**Petition No. 1328
Interrogatories
October 11, 2017**

ABINGTON
SOLAR
481 MASHMOQUET ROAD
POMFRET, CT 06259
TOLLAND COUNTY

Exhibit AS-1

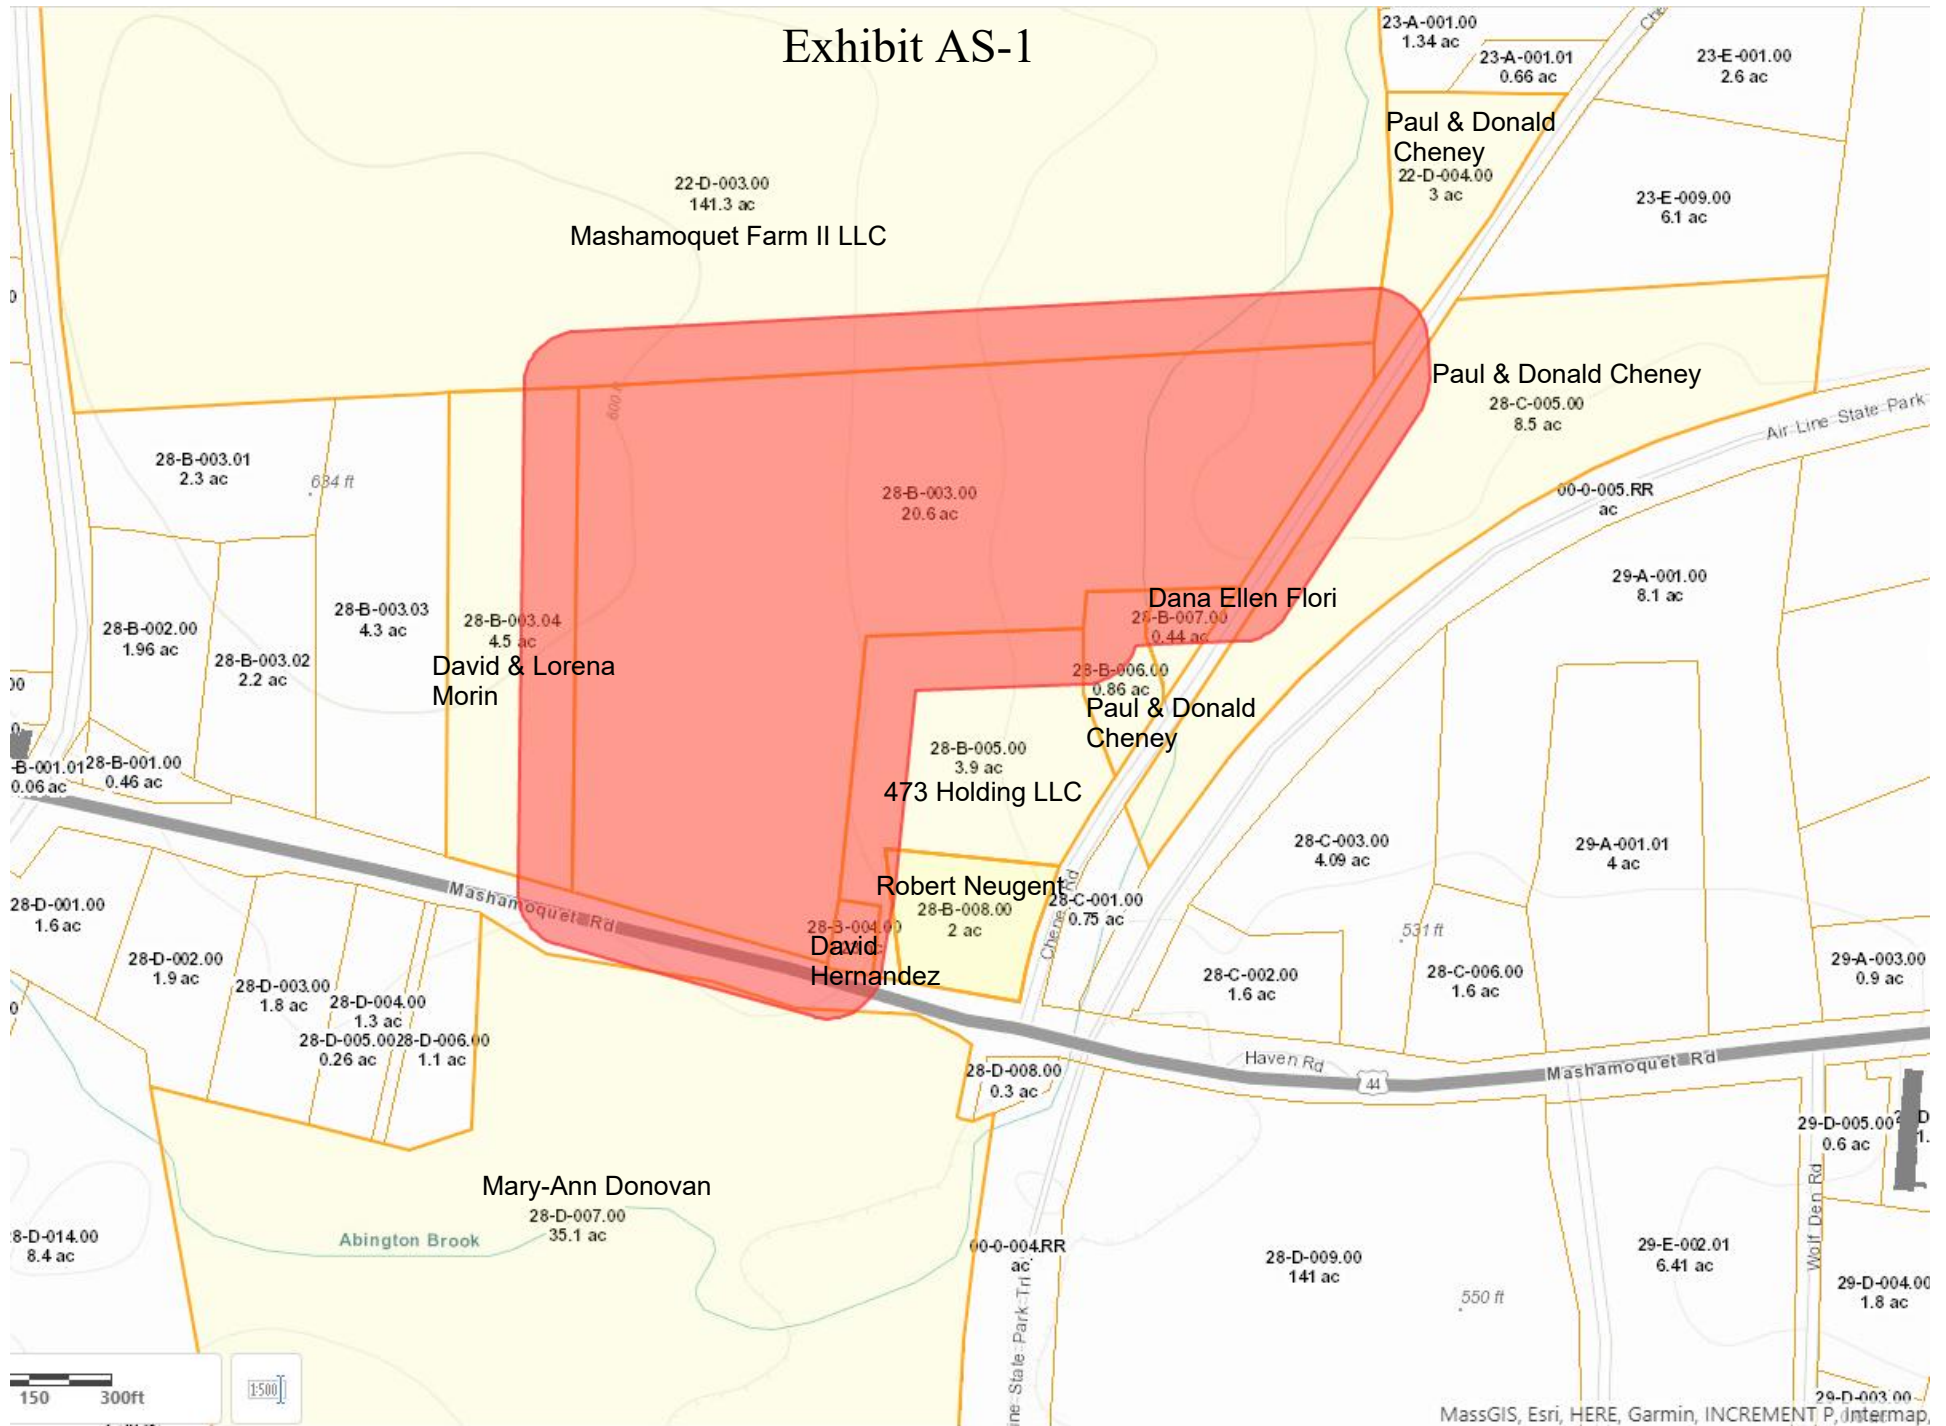
CSC AS 1. Please submit a clearly labeled abutters map identifying each parcel owner corresponding to the names listed on the abutters list behind Tab D of the petition.

Please refer to the map marked Exhibit AS-1, which now includes the names for each parcel owner corresponding to the names listed on the abutters list.

Exhibit AS-7

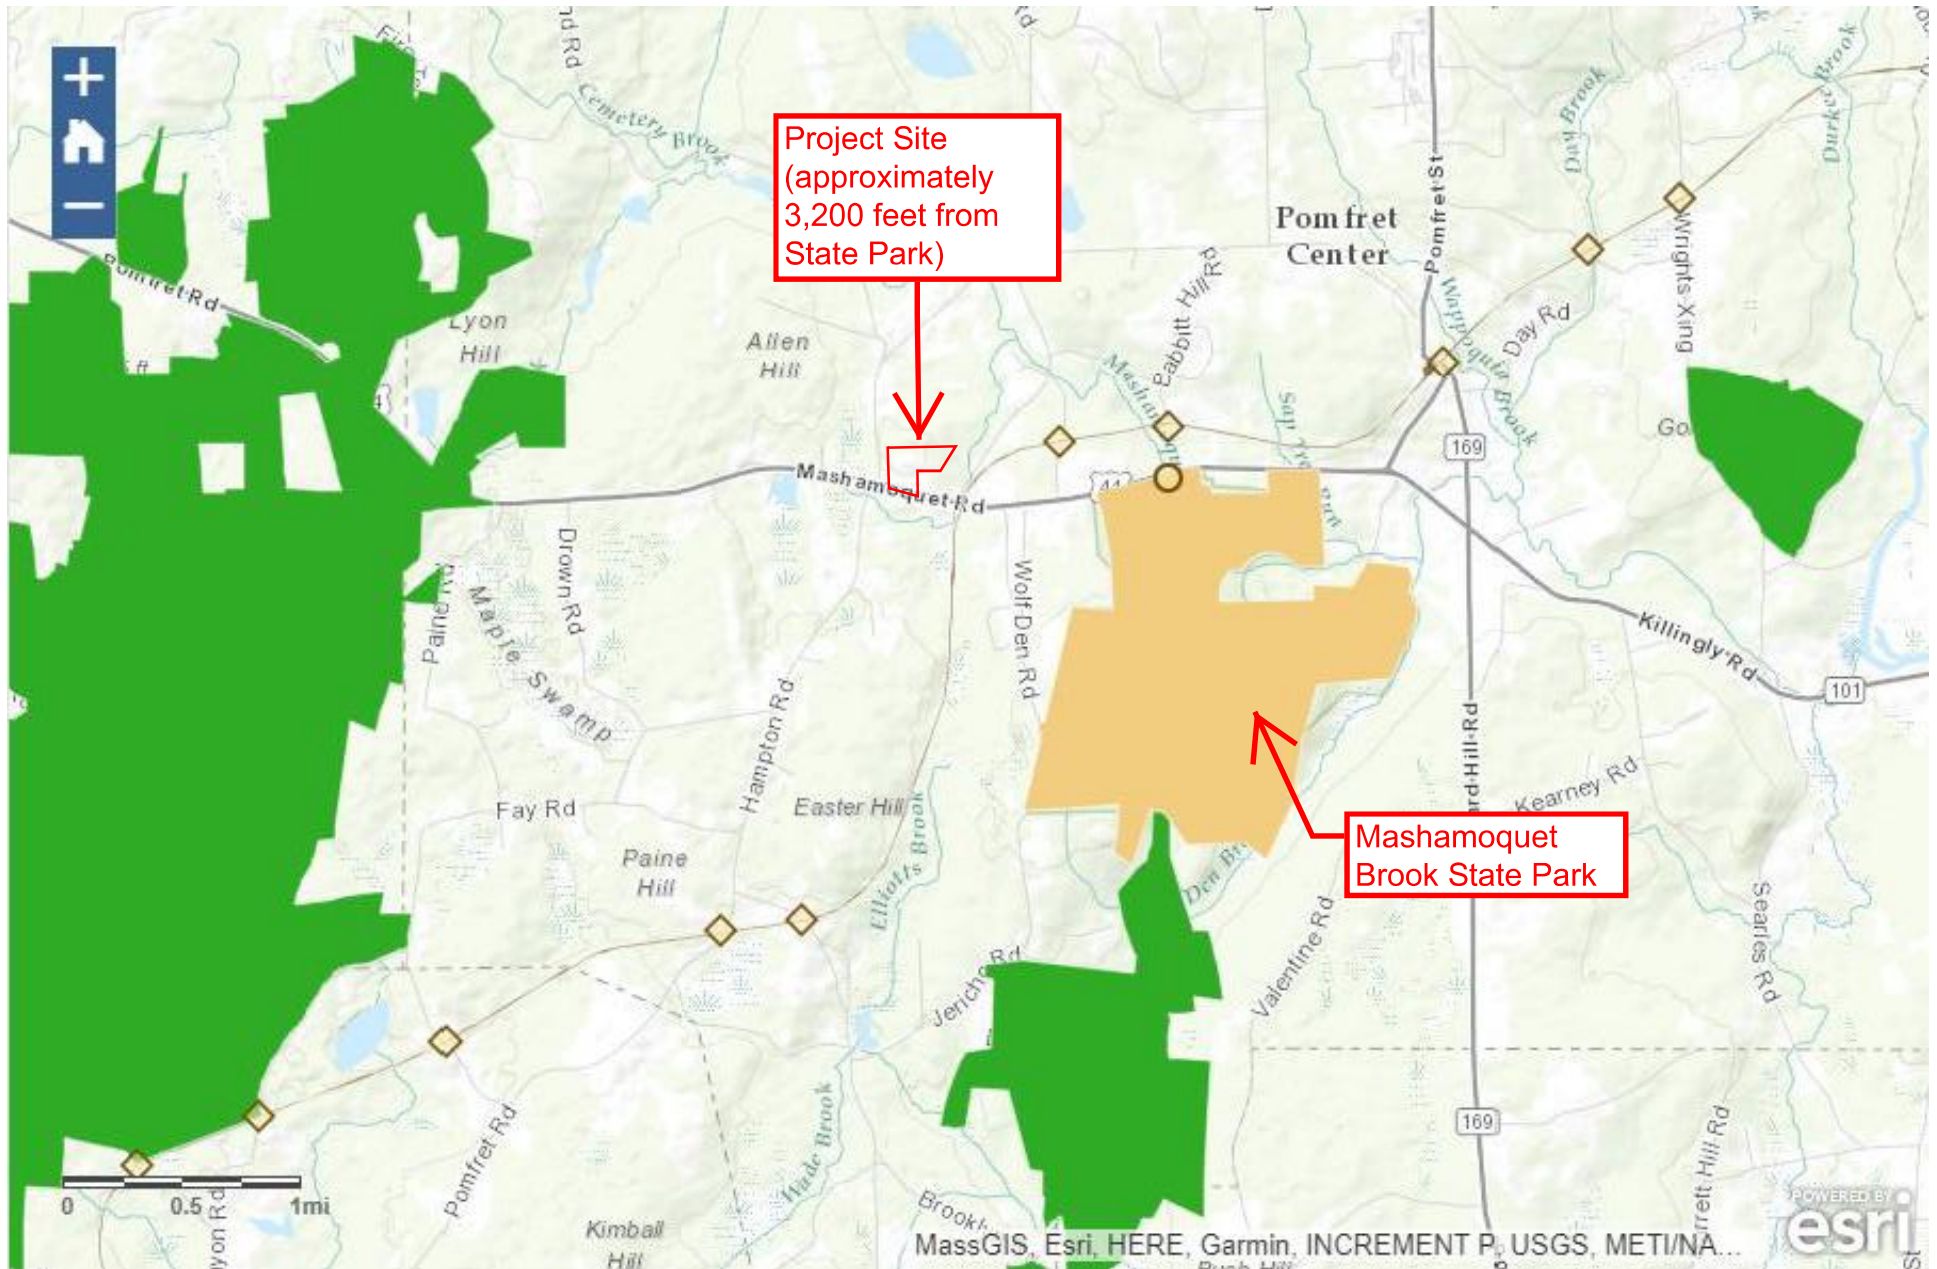
CSC AS 7. Where is the nearest recreational area from the proposed site? Describe the visibility of the proposed project from nearby recreational areas.

Please see the attached Exhibit AS-7 for a map of the location of all recreation areas with respect to the proposed site. Petitioner has not performed a view shed analysis of the solar farm from nearby recreation facilities, however, based upon our site visit, the view of the solar facility from the nearest state park (Mashamoquet Brook State Park) would be screened 100% by existing vegetation and topography. The only other recreation area in close proximity to the proposed solar projects is the Airline North State Park Trail, which is located approximately 900 feet east of the proposed projects. In the case of this trail, there is also heavy vegetation between the trail and the solar projects. Where the trail crosses Mashamoquet Road is the only possible place where the solar projects may be visible and in this location the elevation is 521 feet whereas the solar projects' site is at approximately 600'. The lower elevation of the trail and existing vegetation would make it impossible to see the proposed solar projects from the trail.

Exhibit AS-11

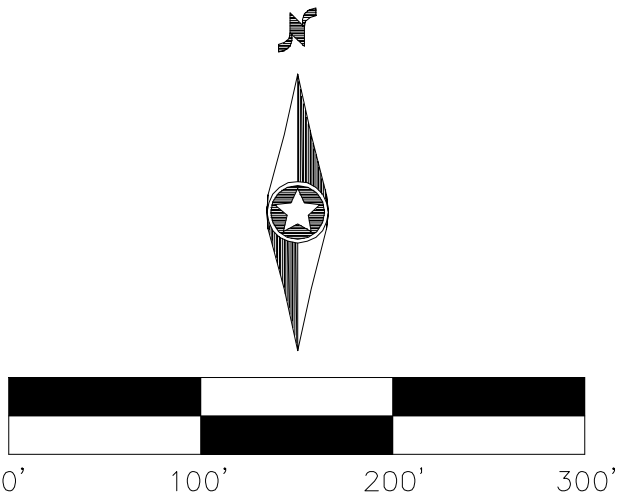
CSC AS 11. Does the proposed site contain any Connecticut Prime Farmland and/or Important Agricultural Soils? If so, what acreage of prime and important soils would the solar panels and associated equipment be located on?

Yes. The site parcel contains 8.42 acres of prime farmland soils. 5.03 acres of the solar arrays would encumber prime farmland soils. Please reference the map attached as Exhibit AS-11.

Exhibit AS-33

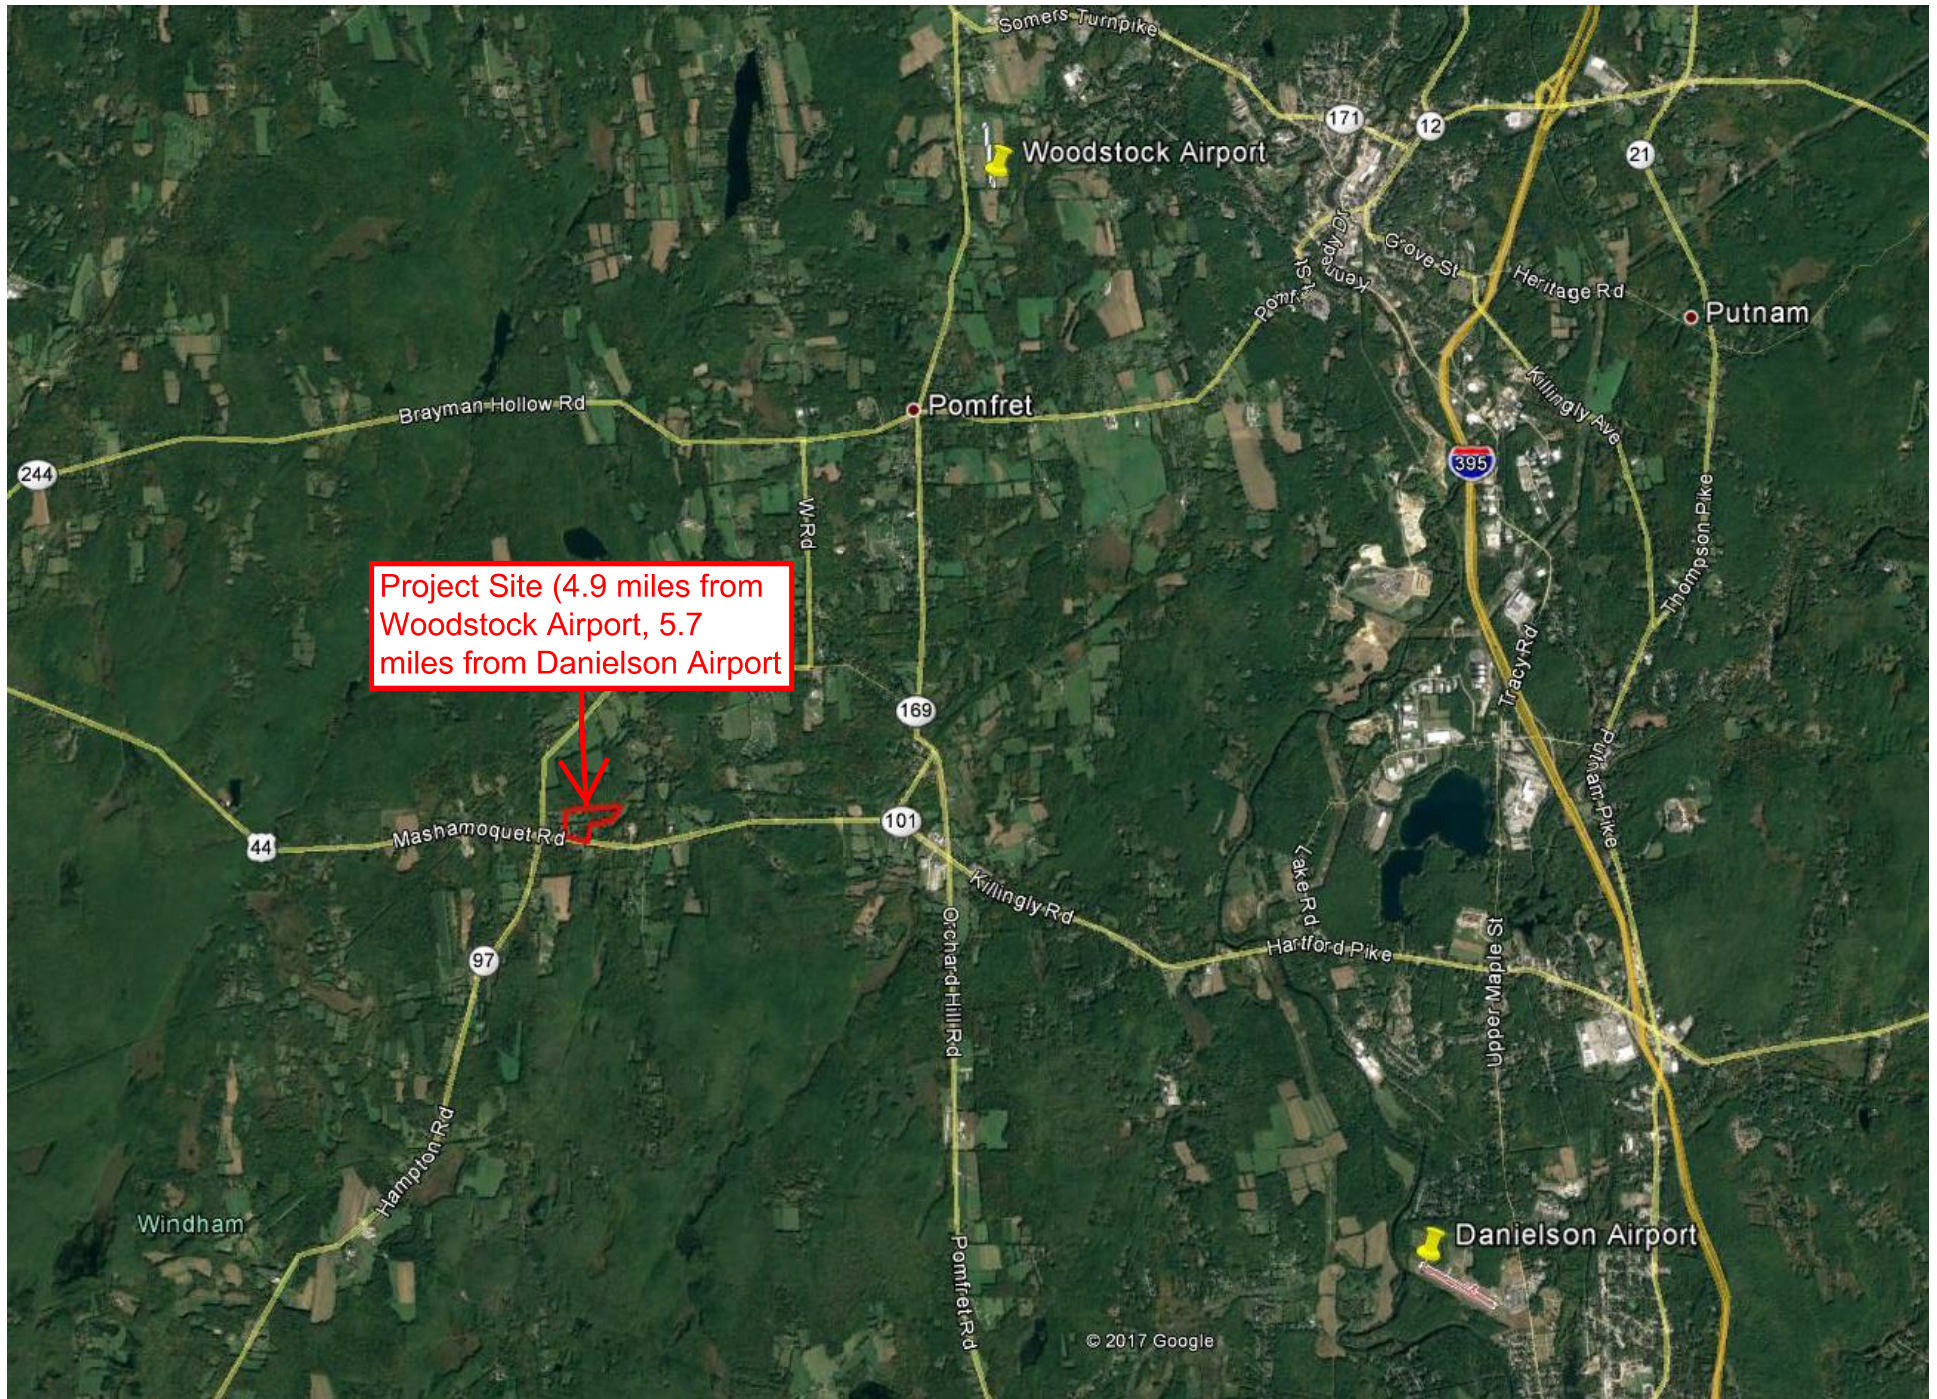
CSC AS 33. Where is the nearest airport and/or airfield? Would glare from the solar arrays have any impact on air navigation? Has a glare analysis been conducted?

The nearest airport to the projects' site is the Woodstock Airport, which is located 4.9 miles to the north/northeast. The Danielson Airport is located 5.7 miles to the southeast. Please refer to Exhibit AS-33.
